TECHNICAL BULLETIN**INSTALLATION****MAINTENANCE ISSUE**

Product : MRLi Lifts using GEV valve assemblies and Pawl Device.

Subject : Modification to power supply wiring.

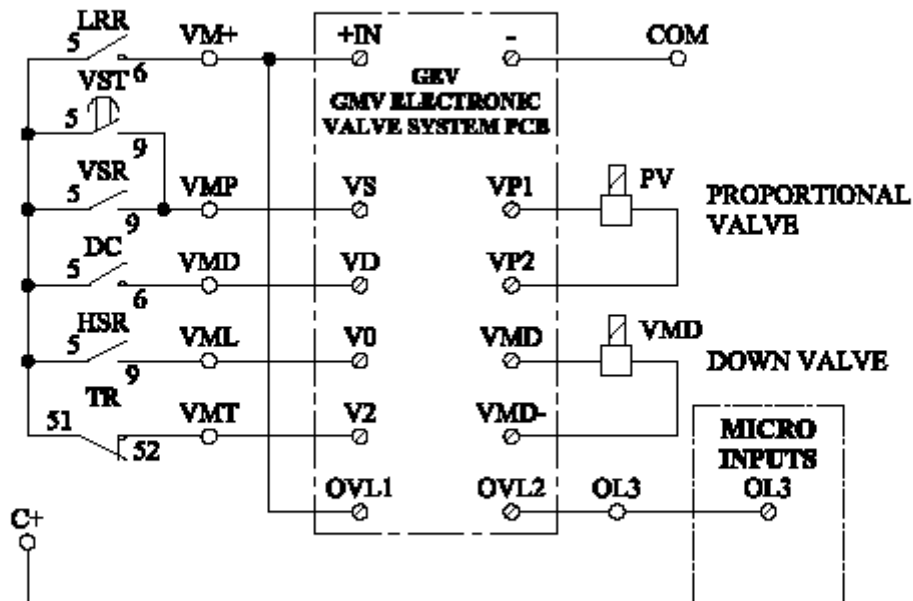
The modification is to change the feed to the valves from VM+ to C+ as shown overleaf.

NAME: G. COOPER	DATE: 22/02/99
CHECKED: E. JACKSON	DATE: 22/02/99
GMV MODIFICATION WIRING FOR DELTA DELTA

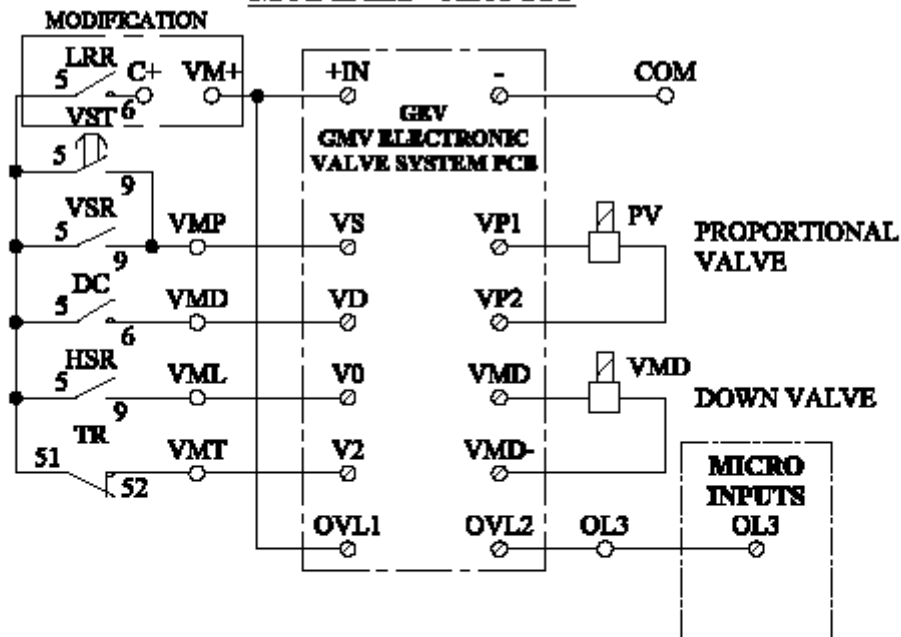
As a result of introducing the Pawl device and Blain Valve to MRLi lifts it has been found that the power required to energise the VMD hydraulic valve is sometimes insufficient. This, in the majority of instances, becomes apparent during testing before handover, but may also present itself whilst the lift is in service. The symptoms are that the lift does not lower with full load in the car.
